Amendment to the Application to the
North Dakota Public Service Commission
for
Consolidated Certificate of Corridor
Compatibility and Route Permit

Case No: PU-11-696

**AVS-Neset 345-kV
Transmission Project**

July 2014

Basin Electric Power Cooperative
Antelope Valley Station to Naset
345-kV Transmission Project
Route Change Map Index

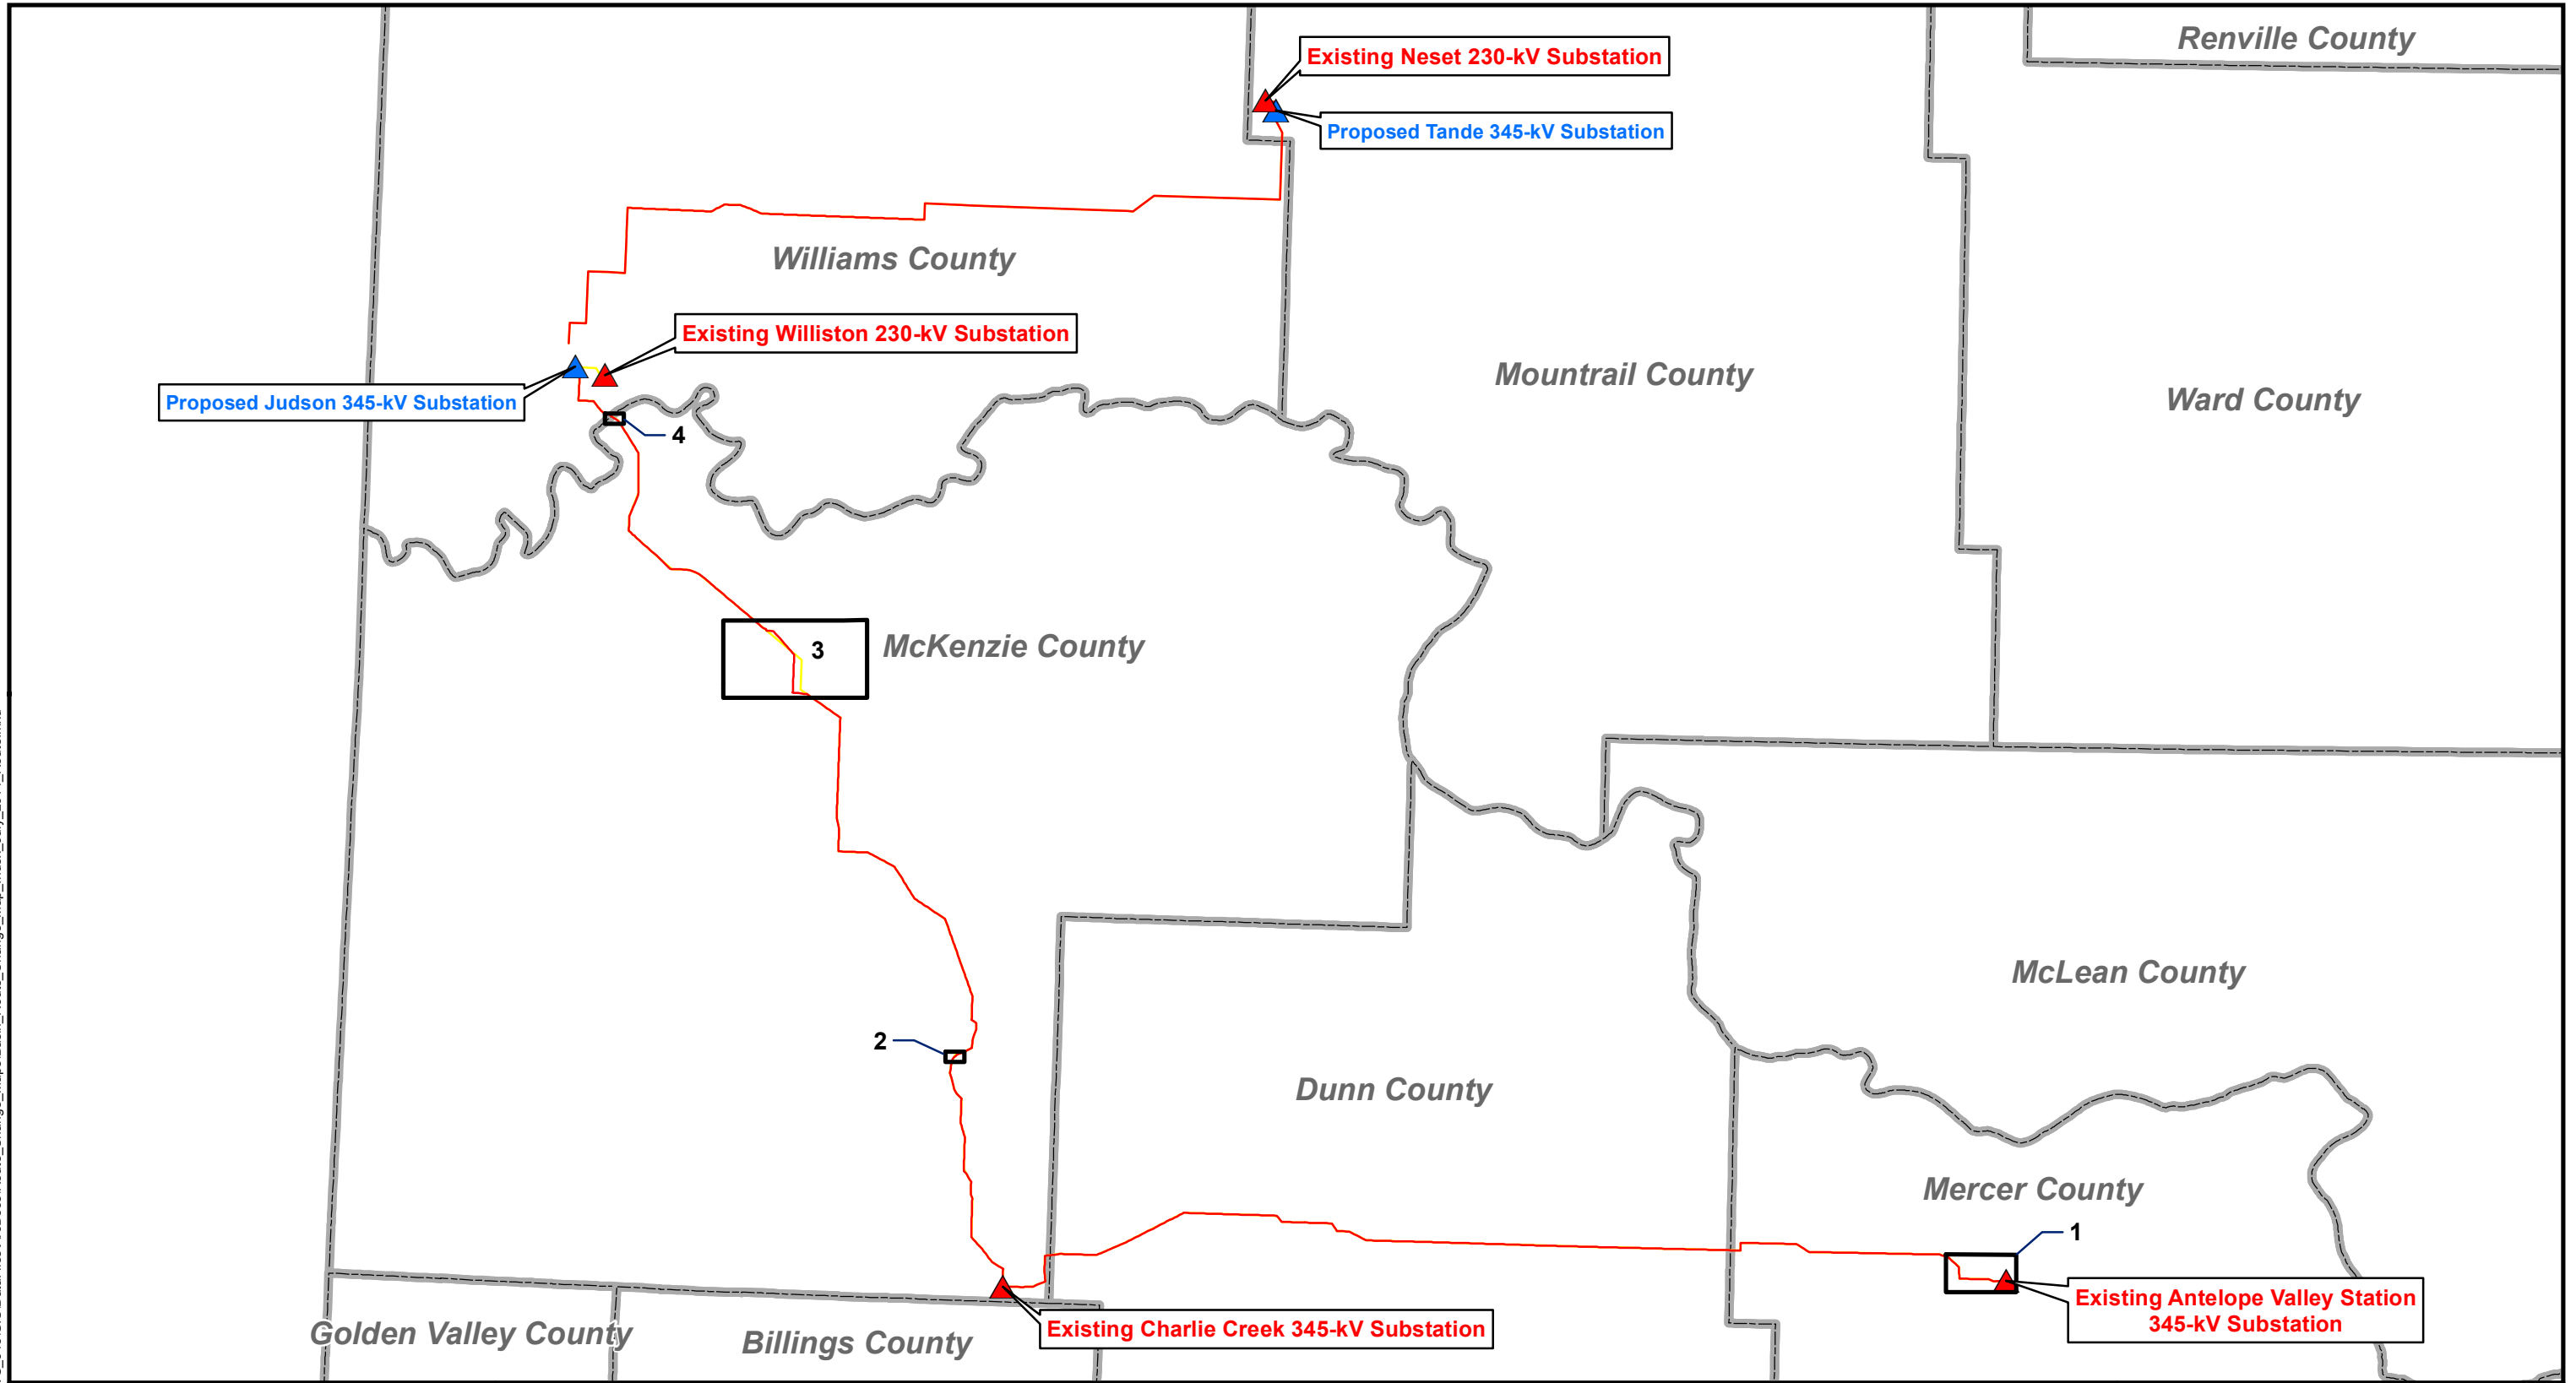
Township	Range	Sections	Reason	Route Change Map Sheet #
145N	88W	14, 15, 23	AVS to Broadland/AVS-Charlie Creek double circuit and relocation of AVS to Leland Olds line interconnection to AVS	Sheet 1a-1b
147N	99W	13, 24	United States Forest Service (USFS) Request	Sheet 2
151N	100W	5, 8, 9, 10, 15, 16,22, 26, 27	Addition of the future Patent Gate Substation	Sheet 3
153N	101W	6	U.S. Highway 85 Wildlife Crossing-NDGF Request	Sheet 4

Corridor/Route revisions at the four locations contributed to the overall increase in project length of 0.5 mile. These realignments are described below, presented in Table 1.0-1, and shown on the Route Change Maps following Table 1.0-1.

Basin Electric Power Cooperative
Antelope Valley Station to Naset
345-kV Transmission Project
Route Change Maps
Sheet 1a of 4

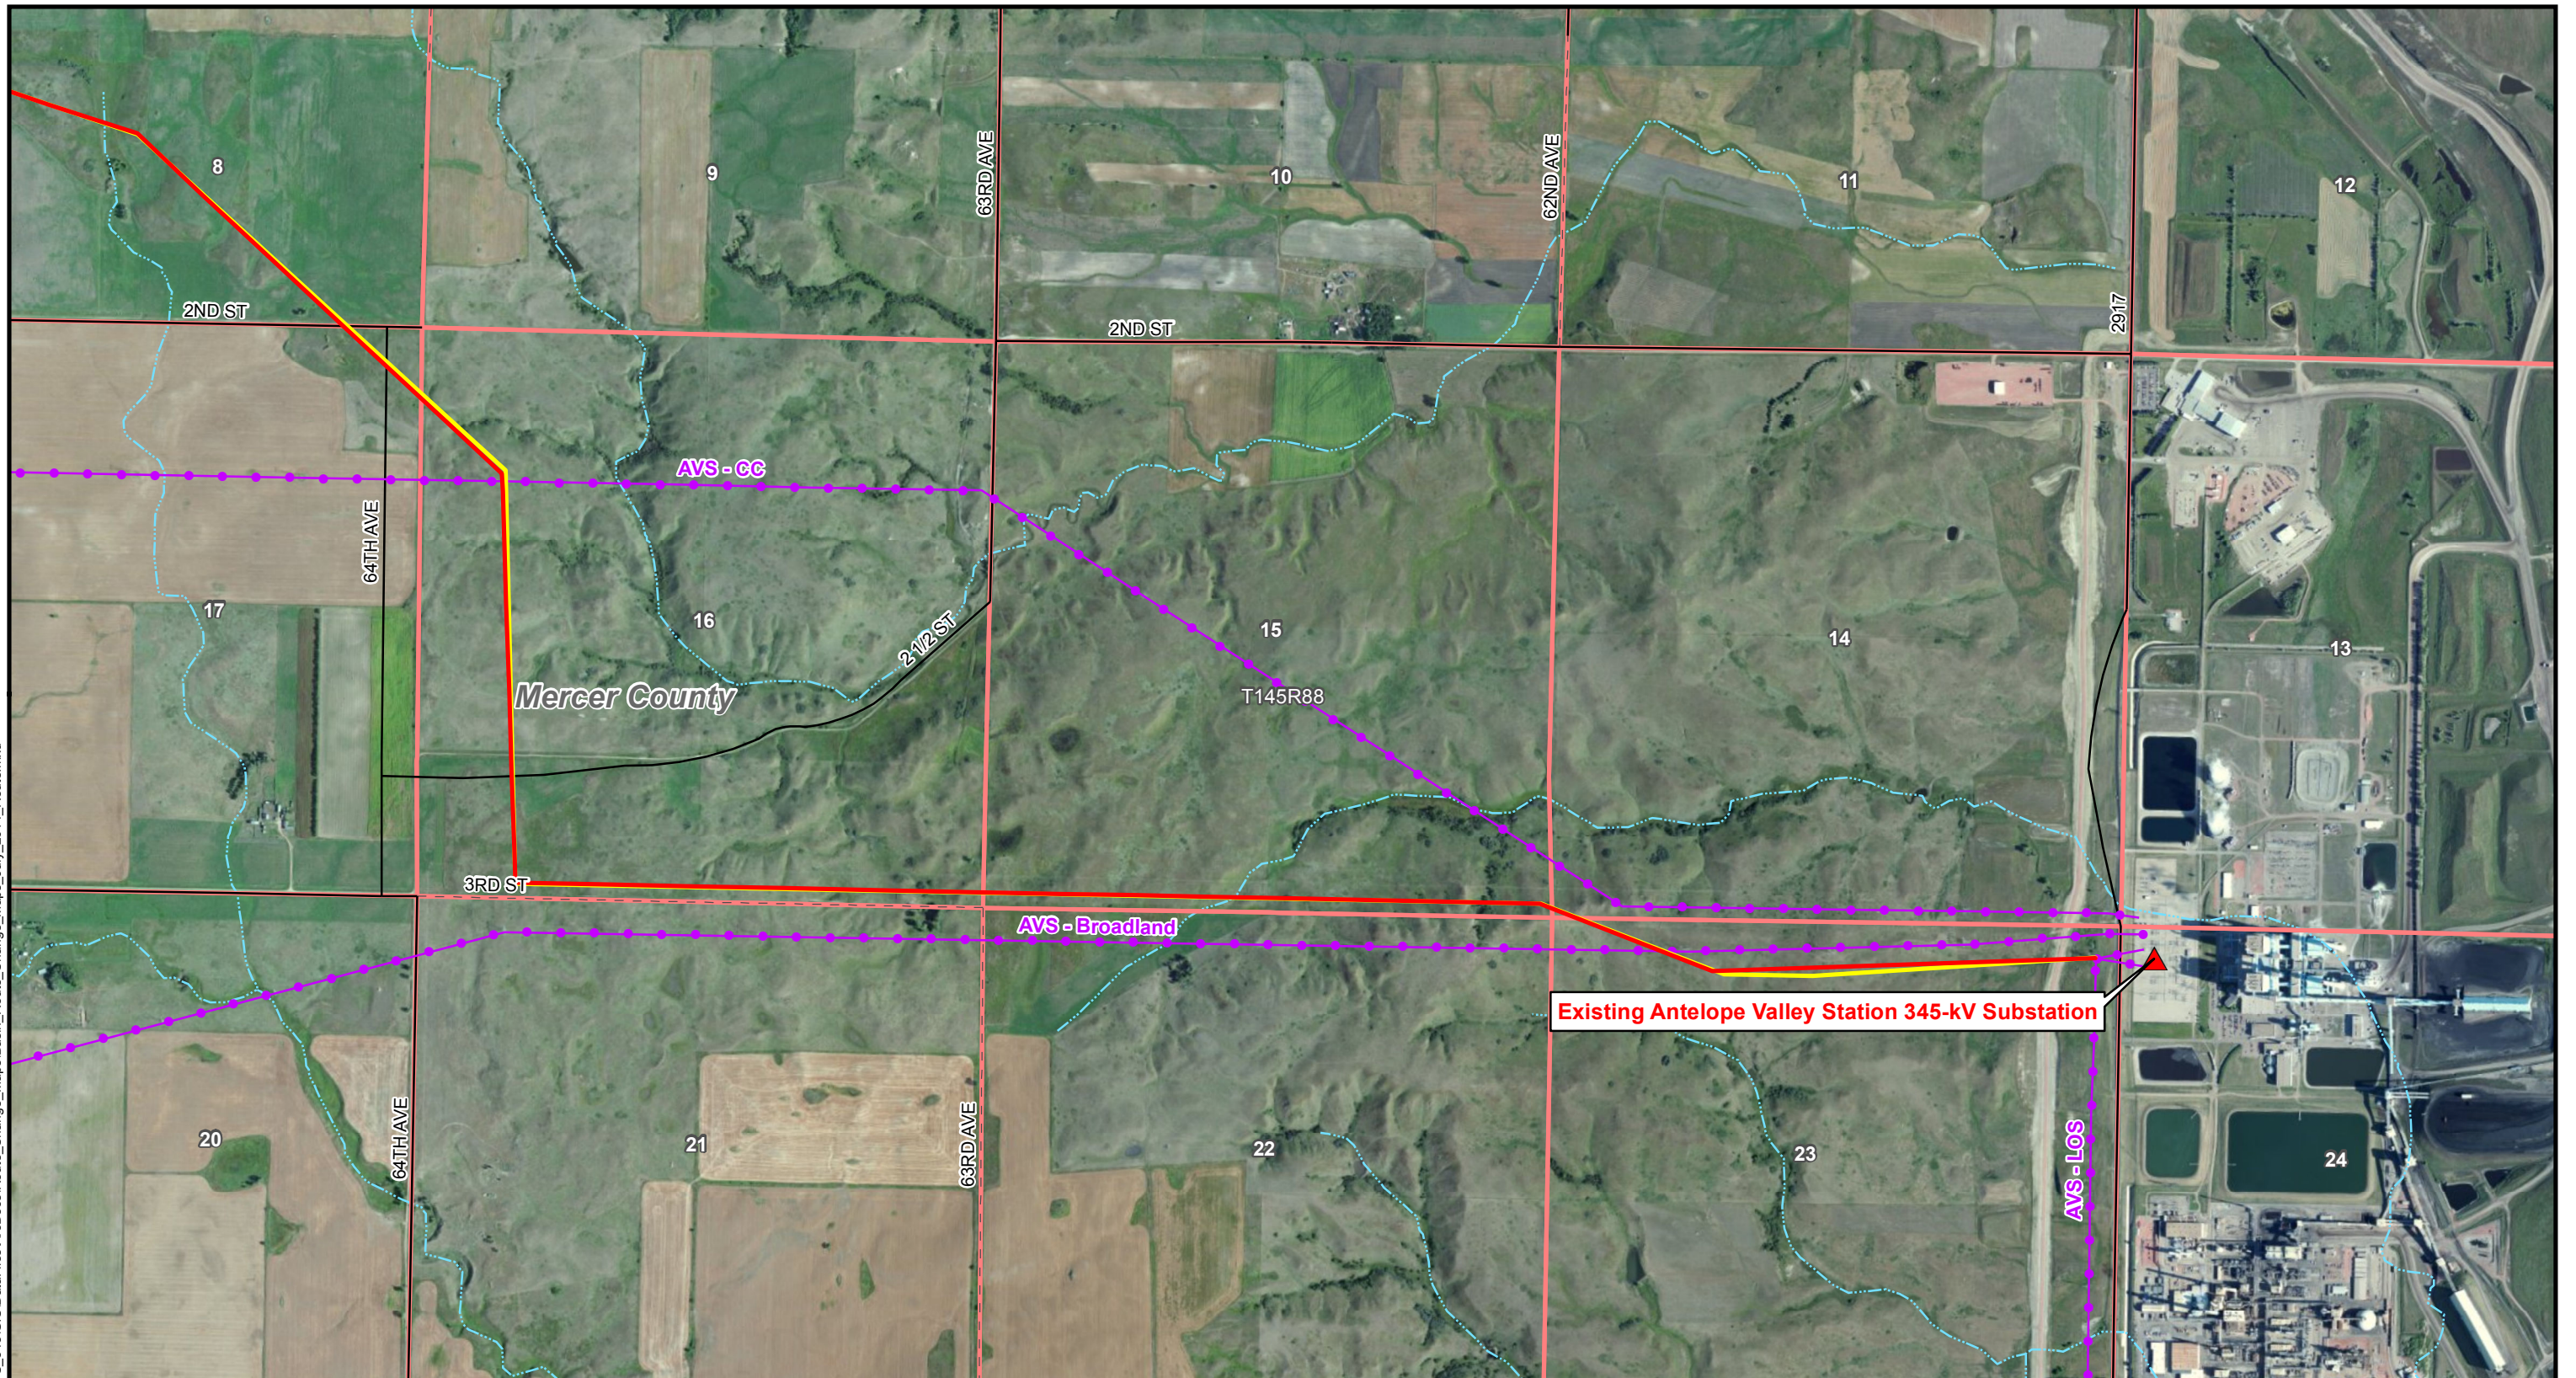
- AVS to Broadland (depicted in Red on Route Change Maps 1a and 1b),
- AVS to Leland Olds (double circuit, depicted in Black),
- AVS to Charlie Creek (depicted in Blue) transmission lines.

The proposed AVS to Neset Transmission line (depicted in Yellow) also requires interconnection to the AVS Switchyard (See Route Change Maps Sheets 1a and 1b). The existing AVS to Charlie Creek (CC) line requires relocation to facilitate mining operations. In Basin Electric's original proposal, this line was proposed to be double-circuited on the new AVS to Neset Transmission alignment for approximately 2.5 miles extending west from the AVS Substation. Upon further analysis and study of this configuration, a concern was raised that double circuiting both lines extending from AVS to CC would present reliability and National Electrical Reliability Council's compliance issues. Thus, the recommendation from Basin Electric's transmission planning department was to avoid or minimize the amount of double circuiting of the existing and proposed AVS to CC circuits, placing as much of these circuits on different structures as practicable. By incorporating separate structures for each line, transmission delivery between the same geographical areas would not be subject to a single event failure.
